Riverside Energy Park, Belvedere

Planning Inspectorate reference: EN010093

National Infrastructure Project Development Consent Order application - Written representation

Chart 1: Cory RRRF carbon intensity vs BEIS projections

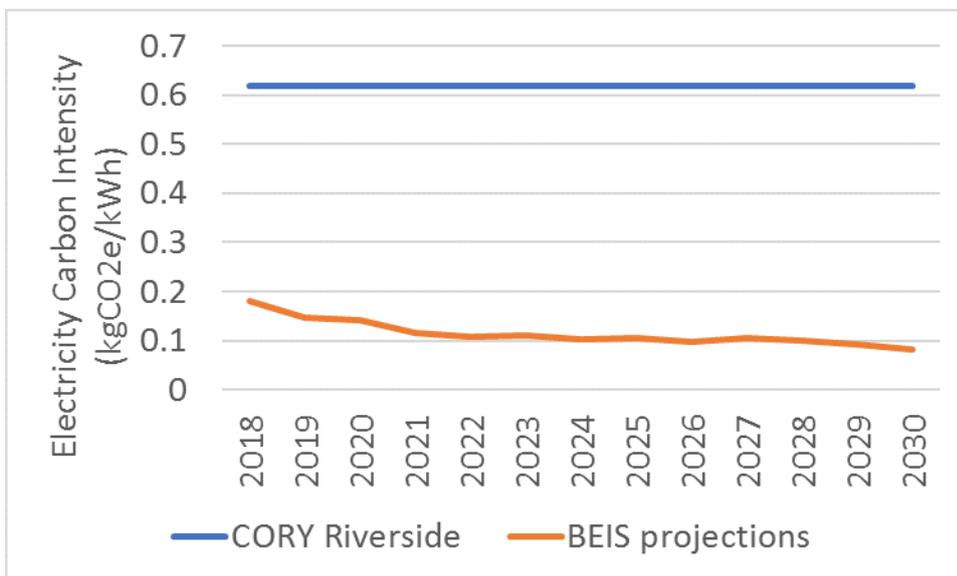
3.56. However, the electricity produced from the existing RRRF has a carbon intensity more than three times the national grid average. The grid average is only projected to fall further in future, as demonstrated in Chart 1 below. These projections are based on BEIS’ electricity supply and dispatch modelling¹³ to assess the likely development of different technologies.

3.57. Although it is acknowledged that the Energy NPS states that EfW facilities can be part of the energy generation mix in the UK, it is clearly stated that only waste that cannot be re-used or recycled with less environmental impact and would otherwise go to landfill should be used for energy recovery.

Chart 2: Forecasted Residual Waste Disposal to Landfill in London and the South East (Tolvik) Error! Reference source not found.

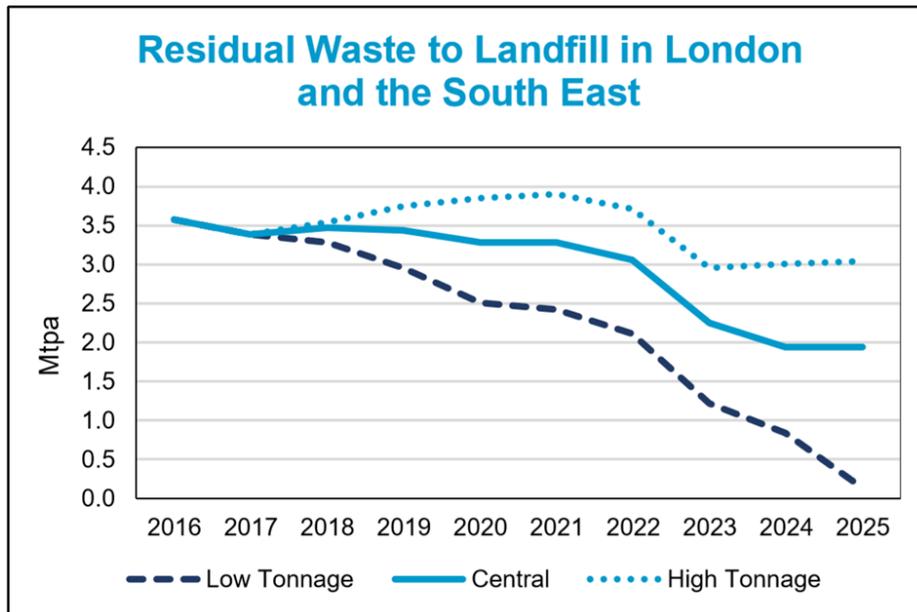
3.83. Independent analysts Tolvik prepared a market study in October 2018 looking at the options for residual waste treatment in London and the South East¹⁷ illustrated below in Chart 2. The Tolvik study findings predict a zero gap under the low tonnage case by 2025 – with the implication of significant capacity oversupply by 2030. In the Tolvik study, the low tonnage case shown on Chart 2 assumes that circular economy targets are met. This assumption is consistent with the GLA approach.

Chart 4: Summary residual waste capacity need across London, surrounding waste planning authorities, and the UK as a whole

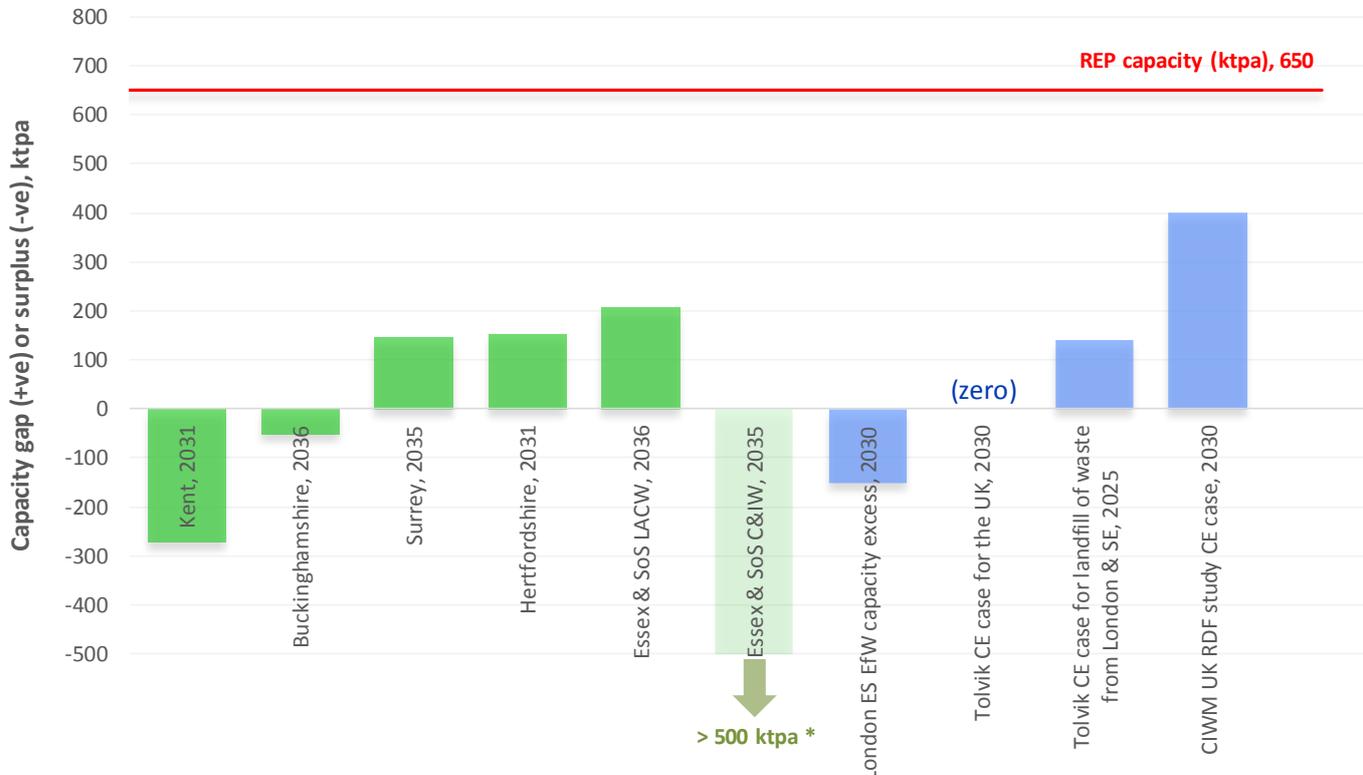
3.86. This analysis of Waste Local Plans demonstrates that while some surrounding waste planning authorities identify a future requirement for residual waste treatment, others anticipate substantial capacity oversupply. Taken together, these findings suggest that no clear case exists for development of EfW overcapacity in London in order to serve regional needs.

3.87. The following figures in Chart 4 brings together capacity gap findings from this initial review of Waste Local Plans alongside regional and national results above.
